Solicitation Solicitation Amendment

1. Amendment Number A01 to Solicitation Number 360070-22-A-0023		Date 08/17/2022		
2a. Facility DAVENPORT, FL - MAIN OFFICE		2b. Project E54635 Building and Parking Expansion		
3a. Offeror Name and Address		3b. Issued By EASTERN FCCMT 7029 ALBERT PICK RD GREENSBORO, NC 27409-9521		
		3c. Contact NIKHIL SONI Nikhil.Soni@usps.gov

5. Description of Amendment: Amendment A01 serves to provide the following: - Pre-Proposal Meeting minutes (Attached) - Revised Offer and Award Page (Please use this page with your proposal) (Attached) - Changes to Specifications (Changes to Alternates) (Attached) - Changes to Drawings (Attached) - Response to Supplier Questions (Attached) All other terms and conditions remain unchanged.

Pre-Proposal Conference Notes.
Davenport MPO Building & Parking Expansion
August 10, 2022 – 1:00 PM

DEDUCTIVE ALTERNATE

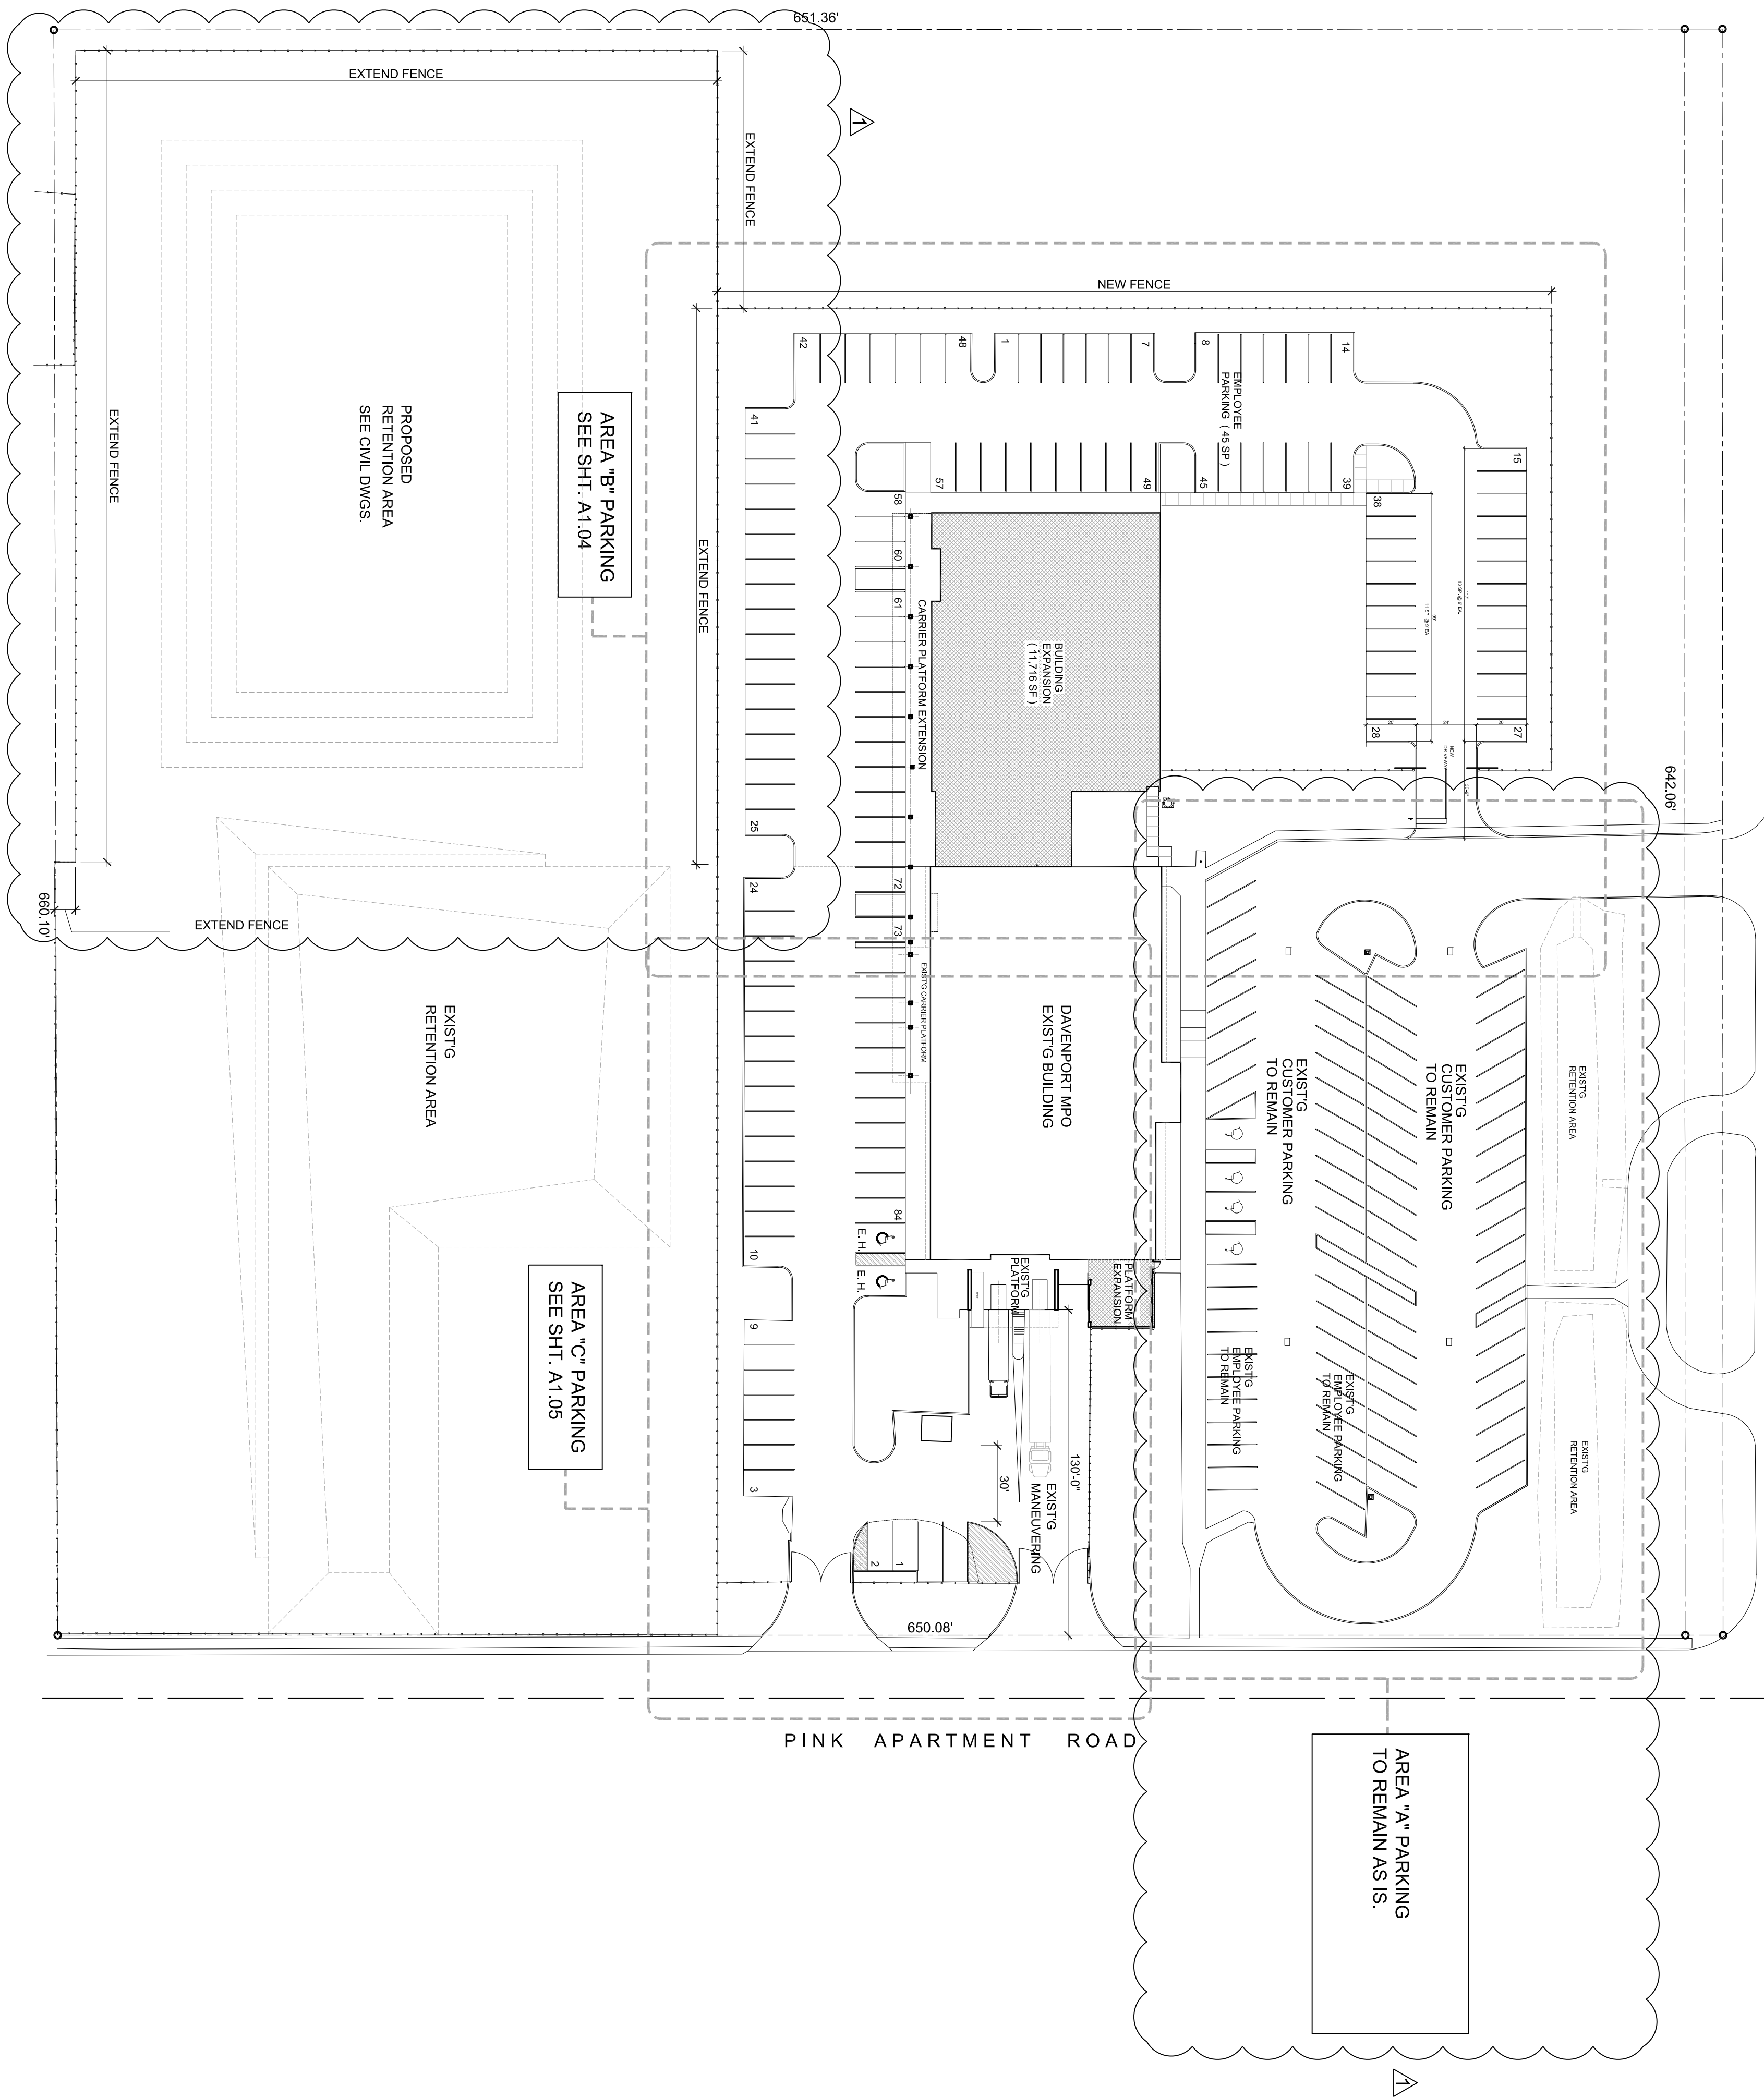
DEDUCTIVE ALTERNATE NO. 2
 CUSTOMER PARKING TO REMAIN AS IS - NO MODIFICATIONS

PARTIAL SITE PLAN - AREA "A"
 SCALE: 1/16" = 1'-0"
 0 20 40 60

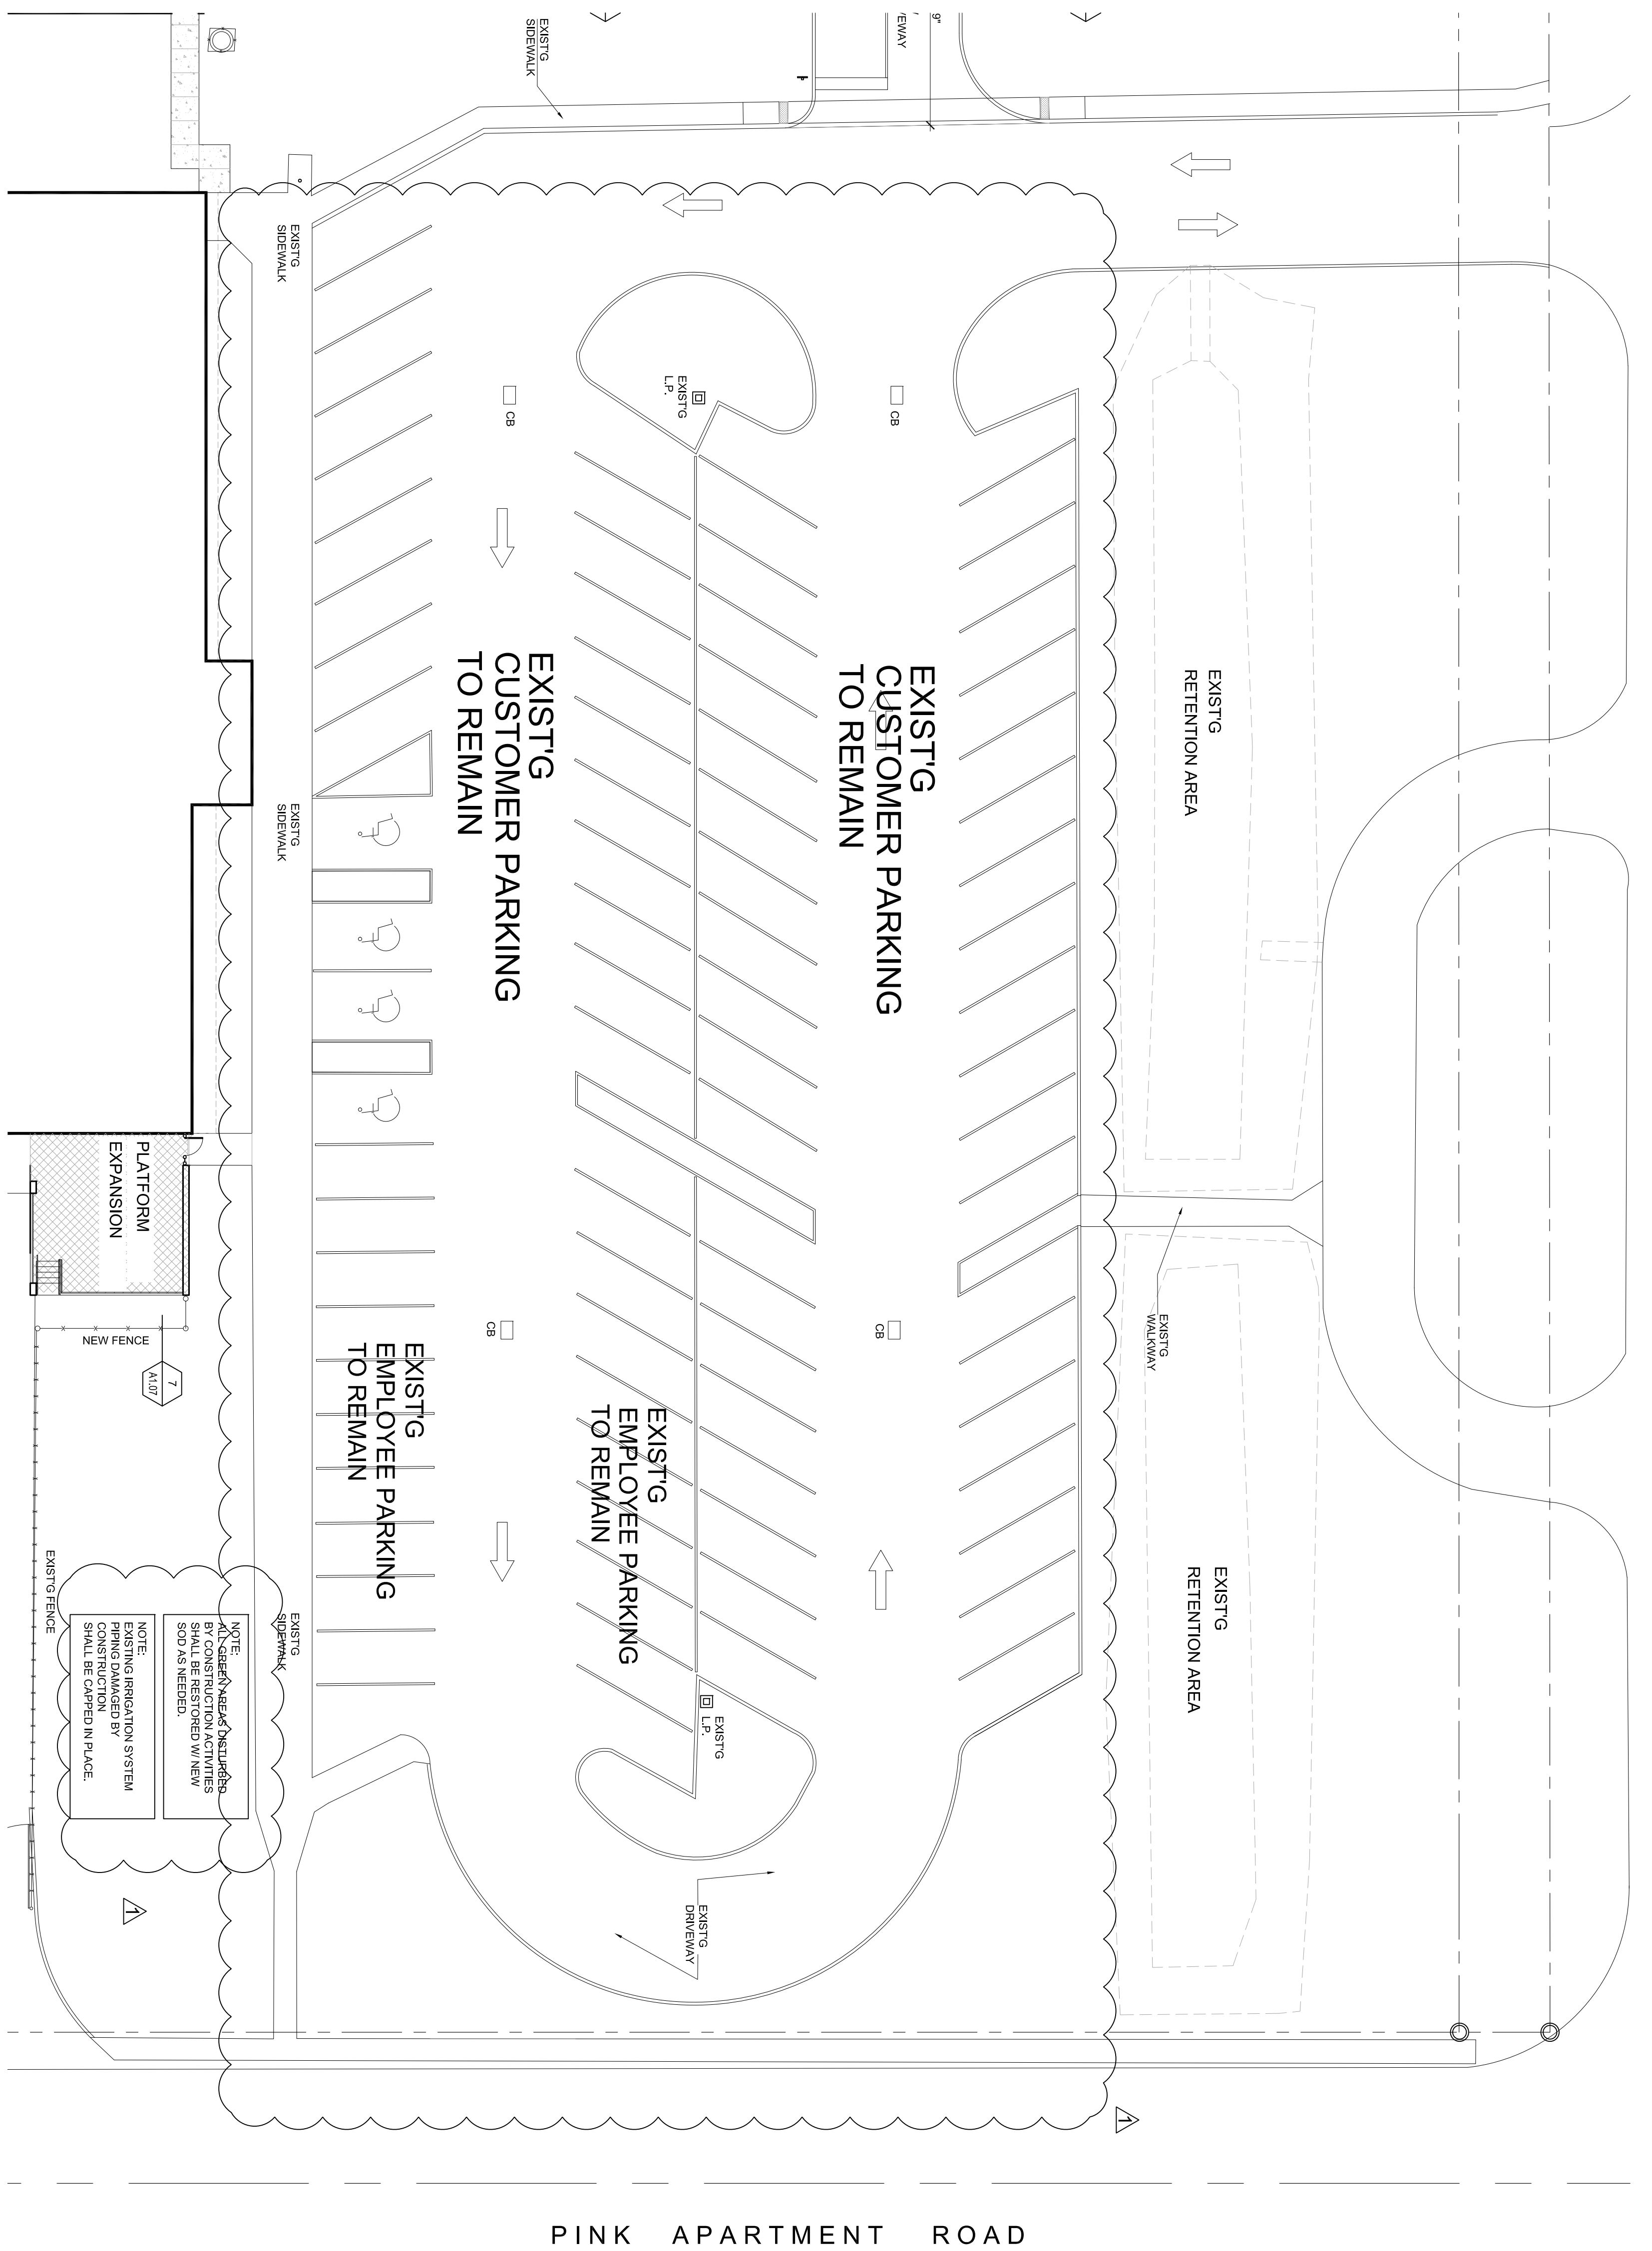
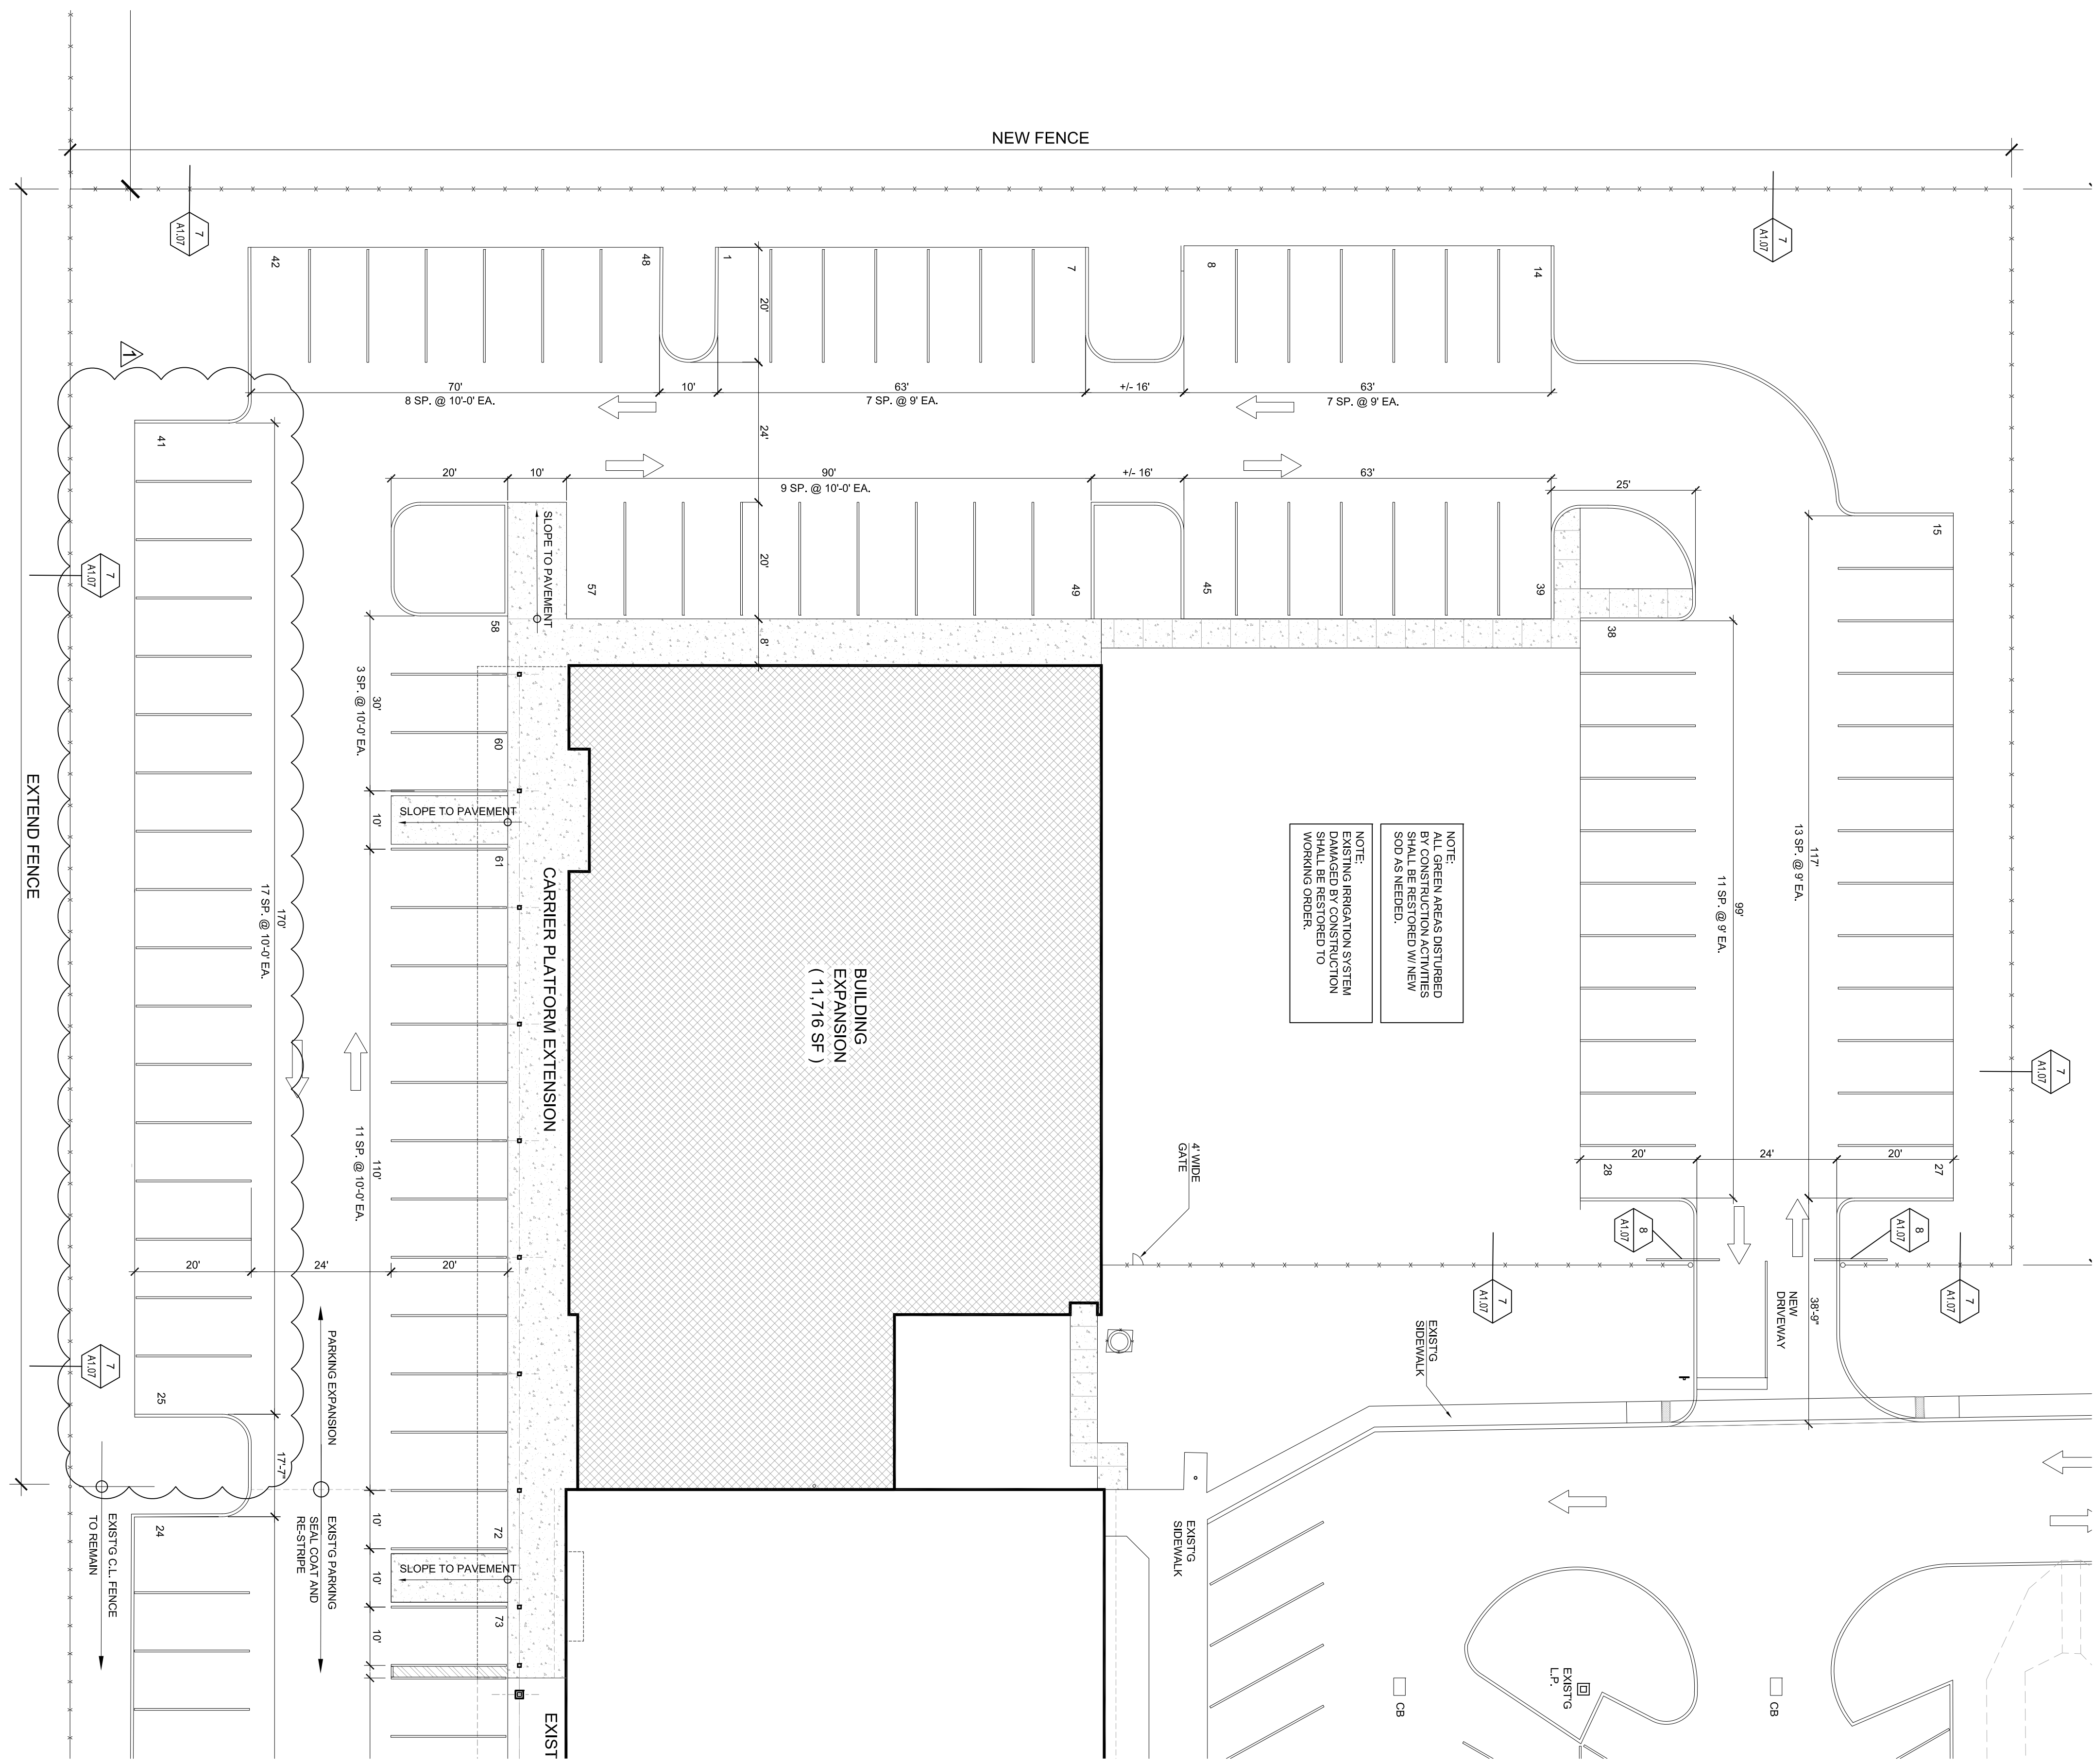
NOTE:
 ALL AREA "A" PARKING TO REMAIN AS IS.
 NO PARKING MODIFICATIONS
